To: Ken Roberts, City of Lake Elmo Planning Director
From: Lucius Jonett, Wenck Landscape Architect
Date: July 30, 2019
Subject: City of Lake Elmo Landscape Plan Review
Springs at Lake Elmo, Review #3

Sheet No. Revision
L1.01

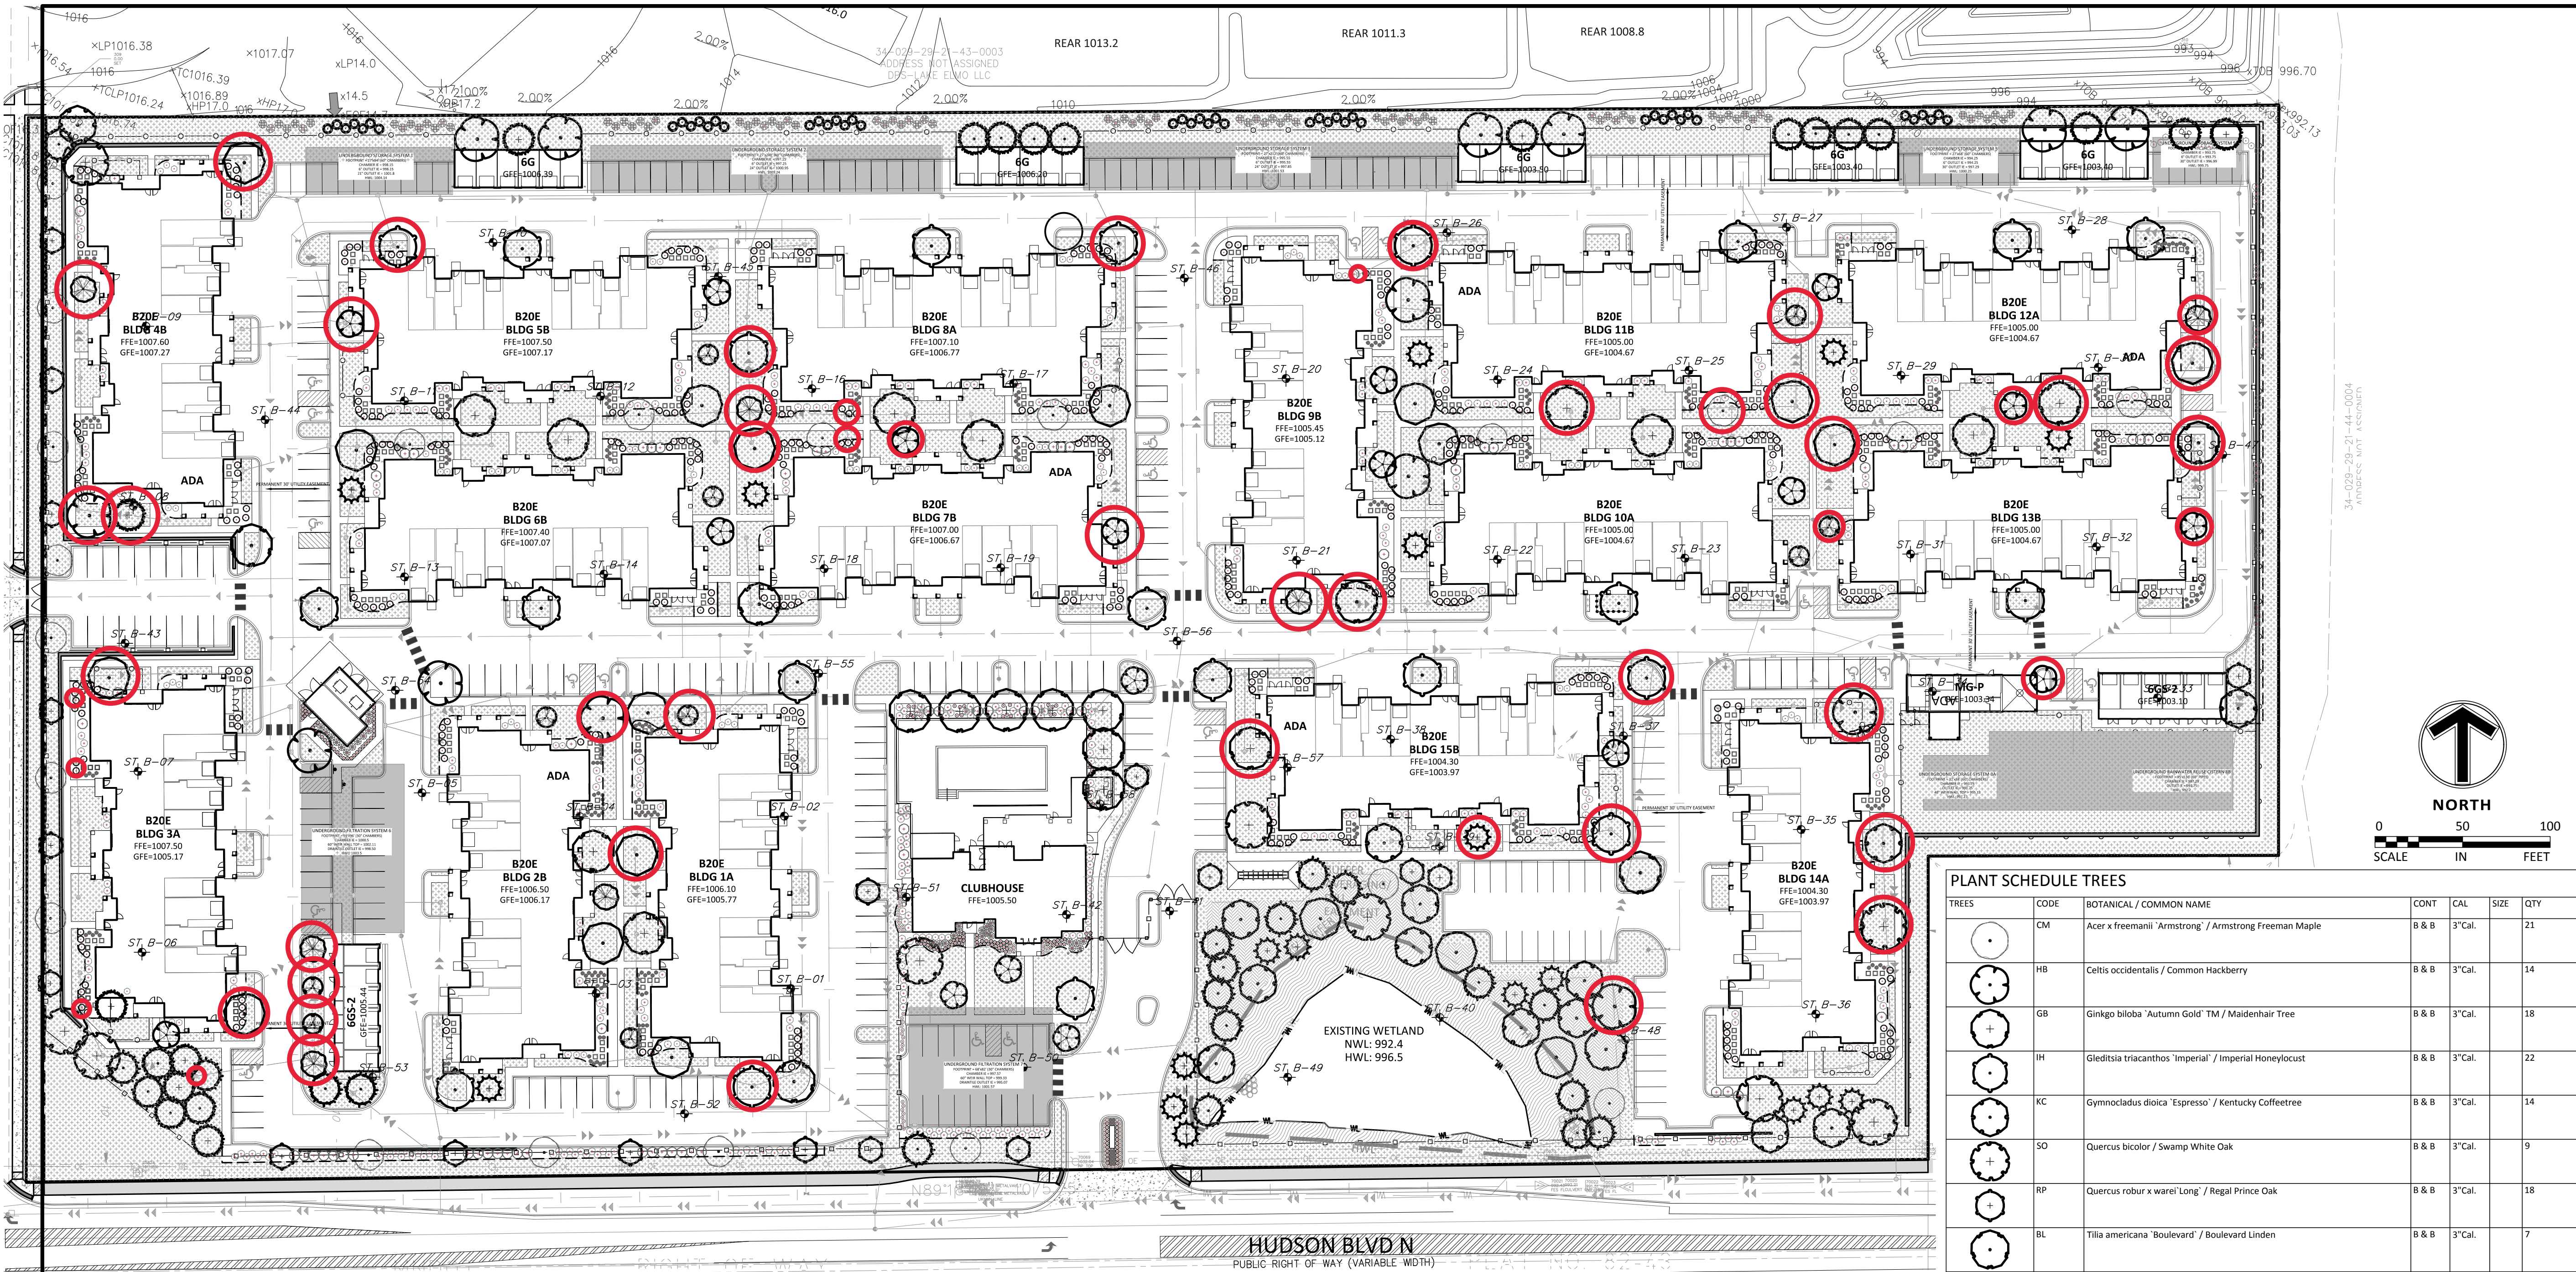
1. No utility conflicts; prefer that the trunk of trees shall be 10 feet from the nearest utility, 5 feet minimum required, including yard drains and storm sewer lines.

1. Resubmitted plans address all comments from the previous review.
2. See attached markup on the landscape plan showing trees in conflict with yard drains and utility lines. There are several constrained open spaces, where after the utilities are installed, field adjustments of trees to fit the remaining open space will be difficult to meet City spacing requirements. The landscape plan needs to be updated with adjusted tree locations to maintain 10' clearance where possible, otherwise maintaining at least 5' as agreed upon.

It is recommended that a condition of final approval includes submitting a revised landscape plan.
